PL202000029
PL2020-29

2020 NEW BUILDING FOR:
WALSER TOYOTA RAMP
4401 AMERICAN BLVD
BLOOMINGTON, MINNESOTA

DATE: 2/12/2020 REG. NO. 17387
ISSUE NUMBER: 2/12/2020 CITY REVIEW

2020 NEW BUILDING FOR:
WALSER TOYOTA
4401 AMERICAN BLVD
BLOOMINGTON, MINNESOTA

A1.0

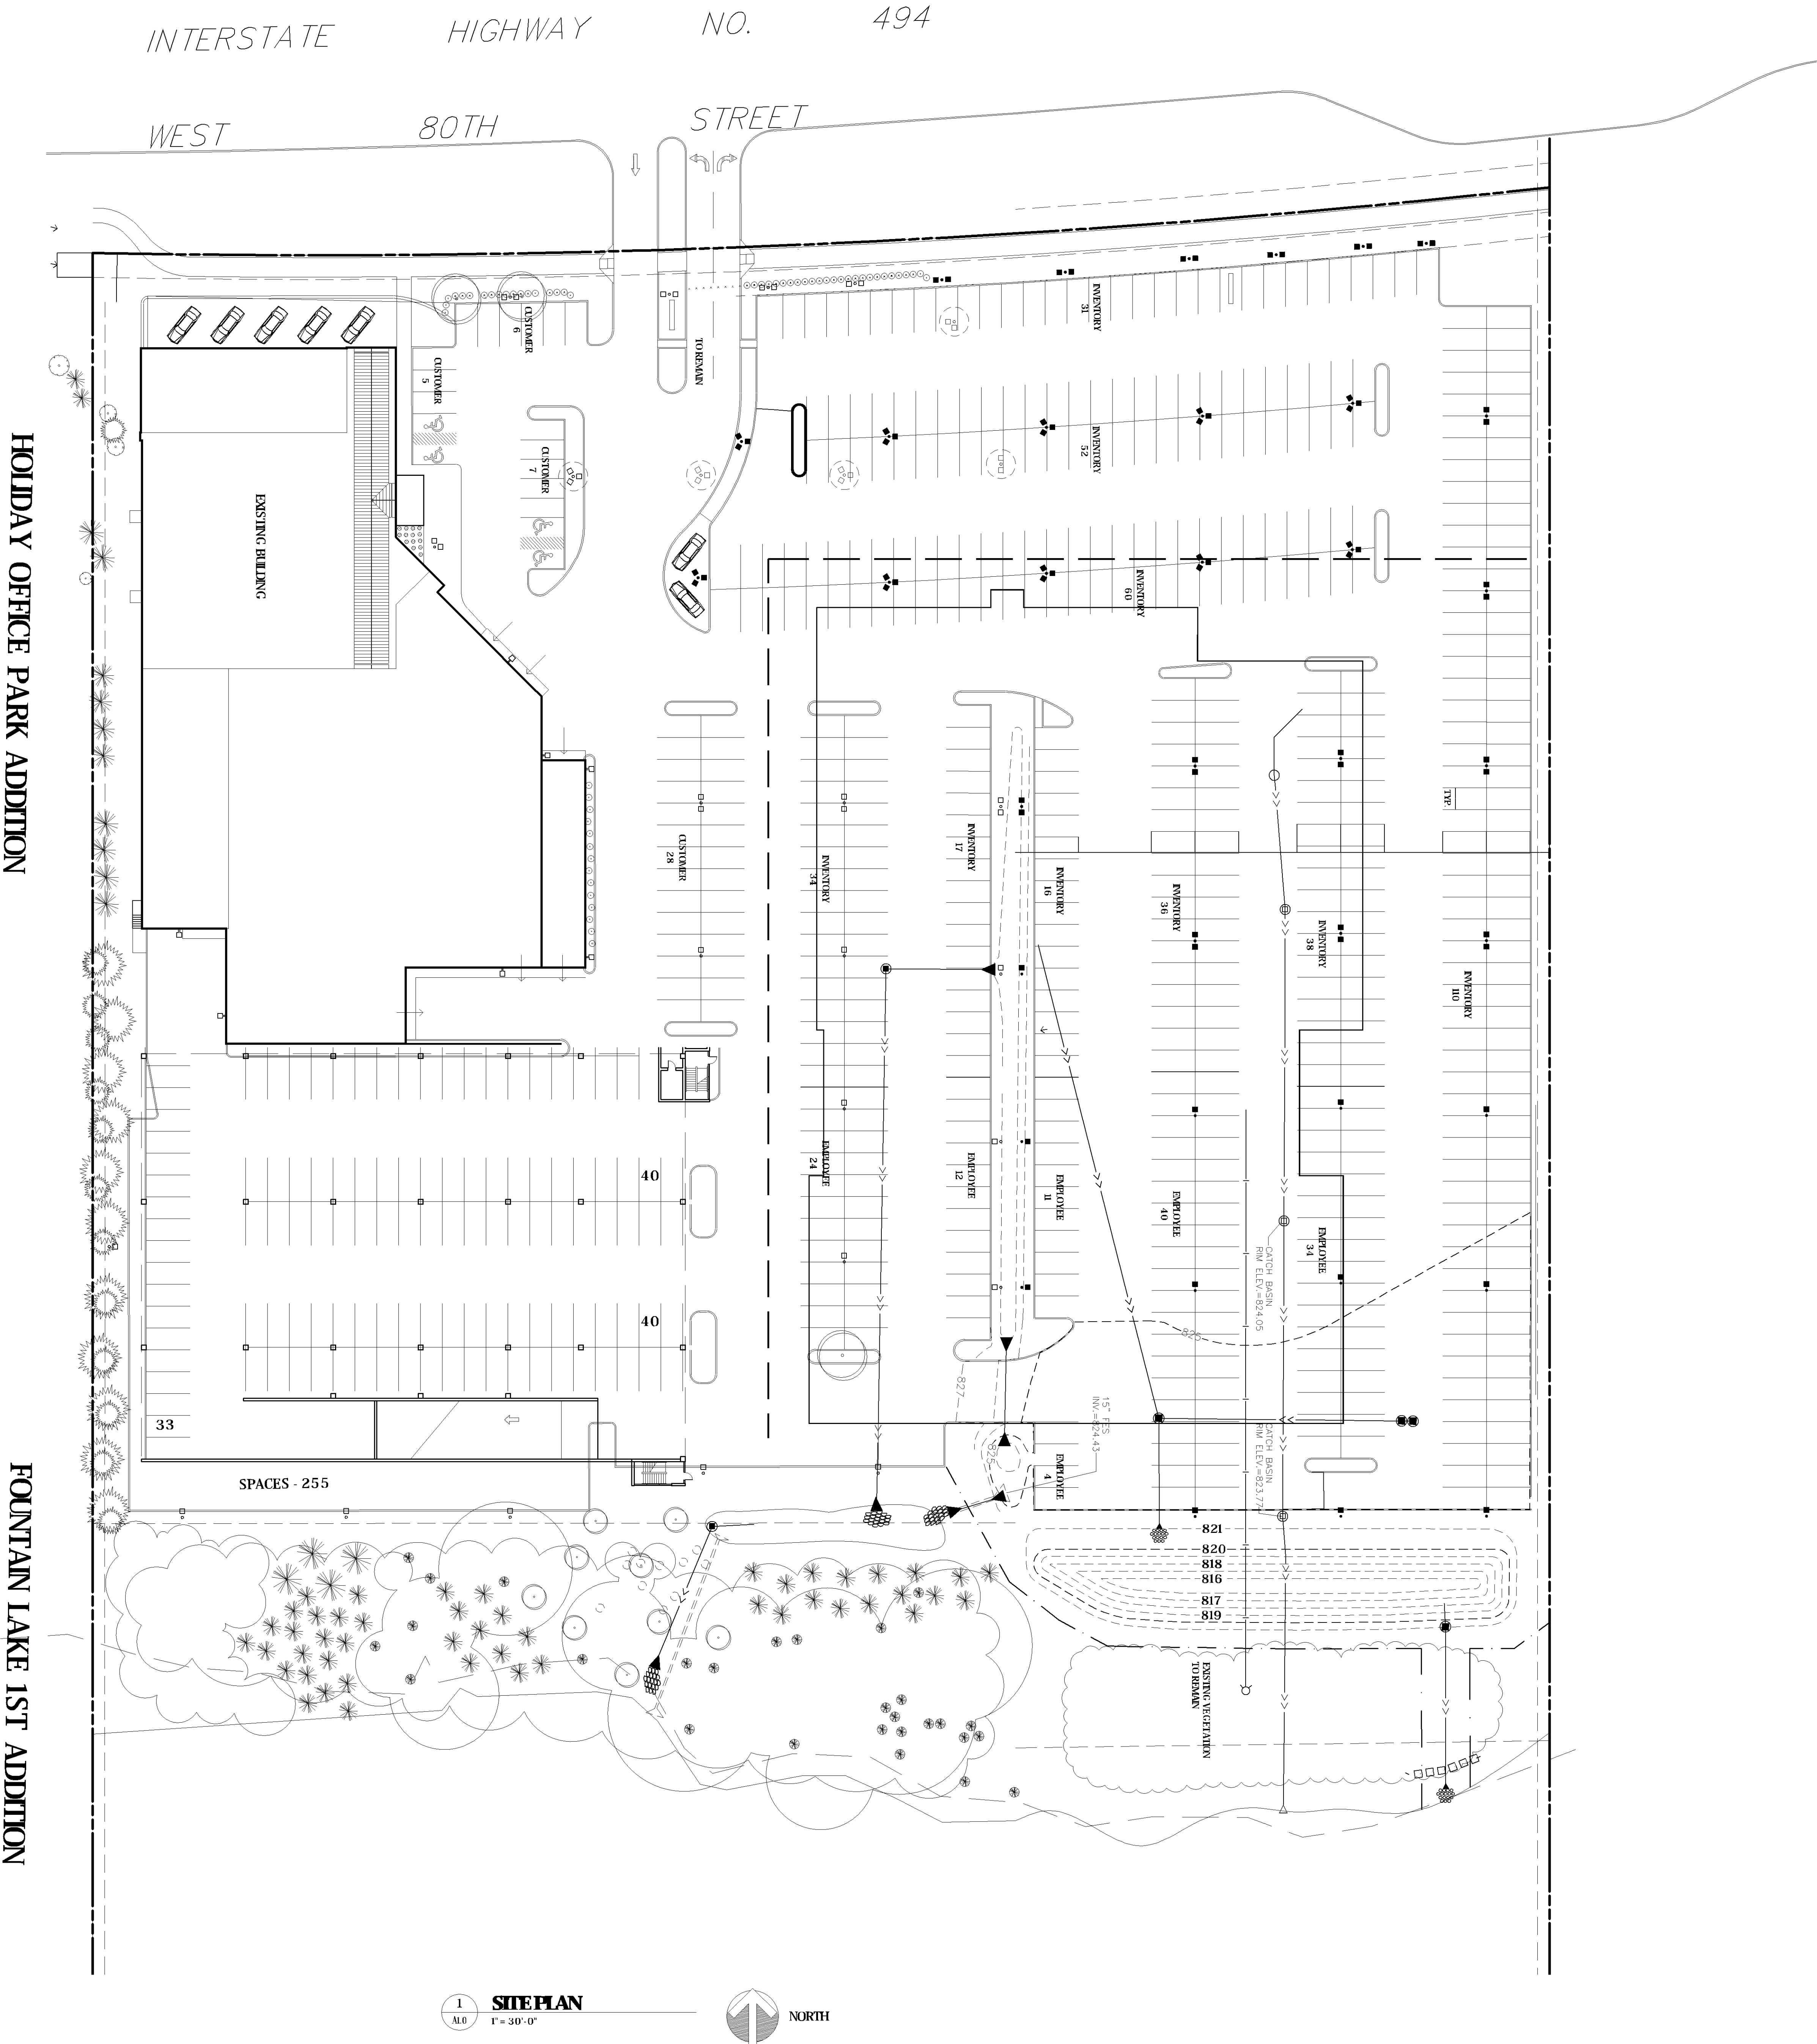
In narrative Phase 1 is parking ramp not building

1 SITE PLAN
A1.0 1" = 30'-0"

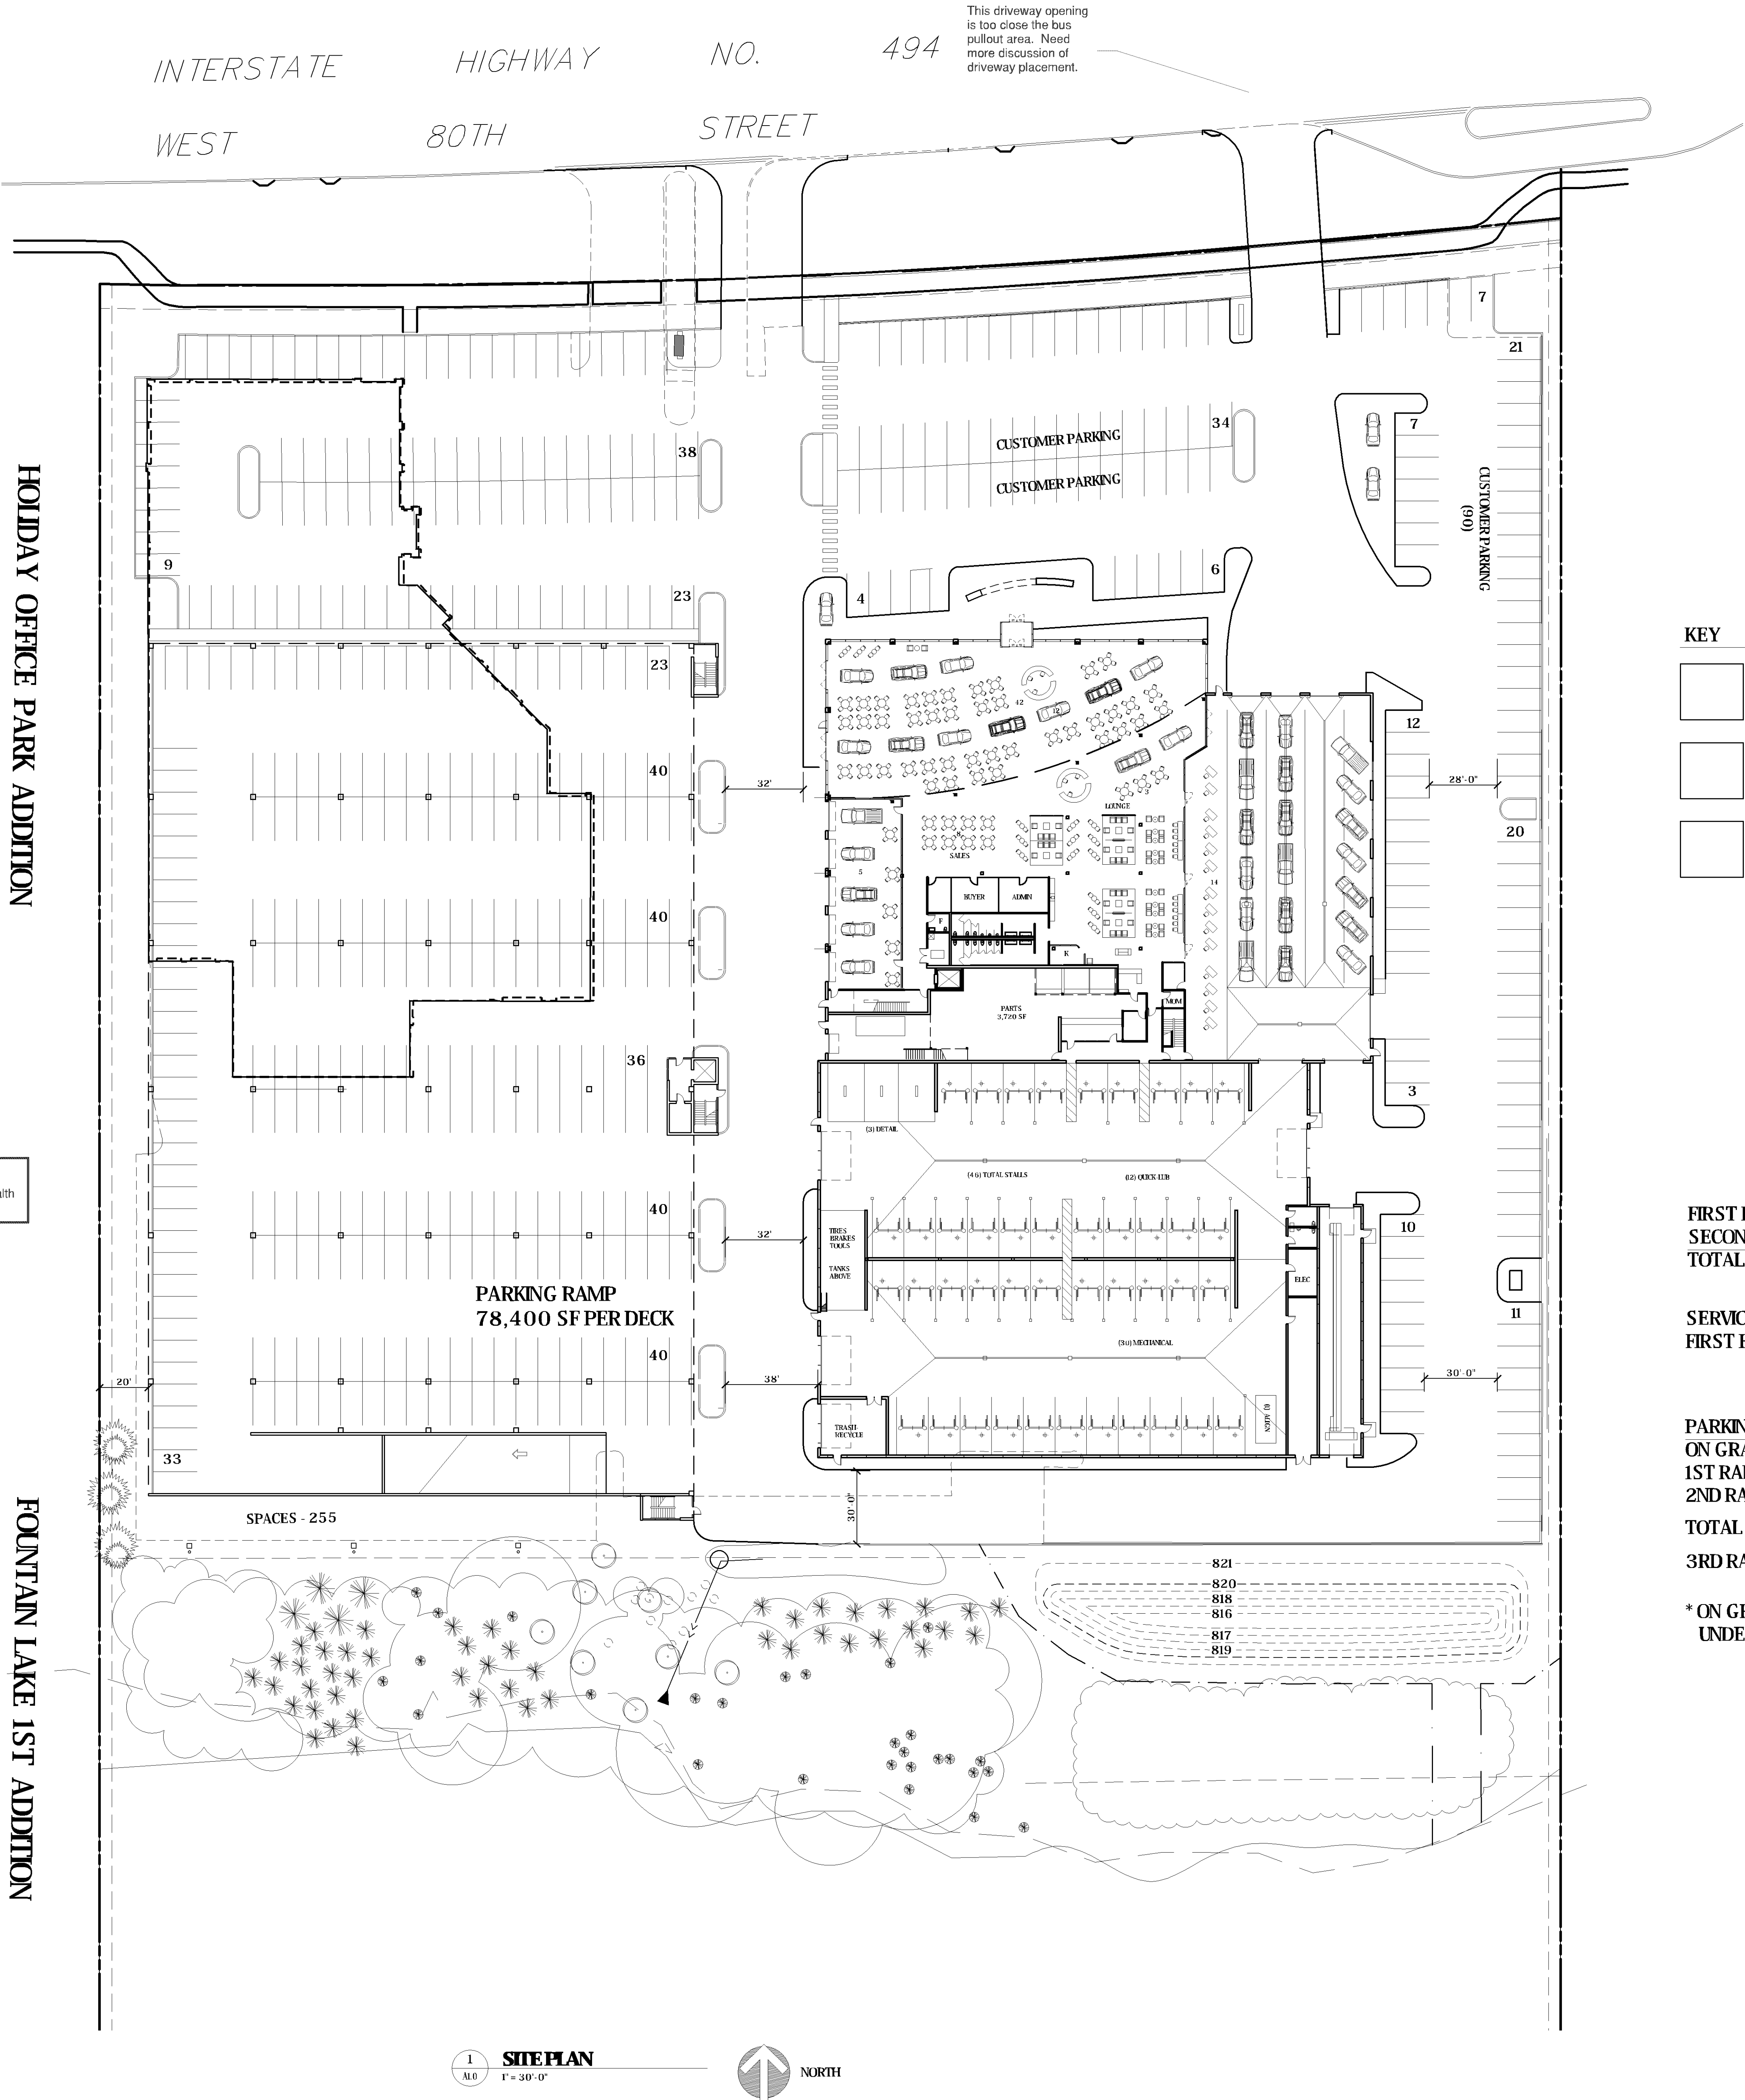
Hydrant coverage shall be provided within 50' of the FDC and within 150' of all portions of the structure.

Provide adequate turning radius for BFD Ladder 4 for all emergency vehicle access lanes.

Provide for emergency vehicle access throughout the property and around the structures. Access roads to be a minimum 20' wide and able to support 40 tons.

Insure the proposed landscaping doesn't interfere with access to the building.

This driveway opening is too close the bus pullout area. Need more discussion of driveway placement.
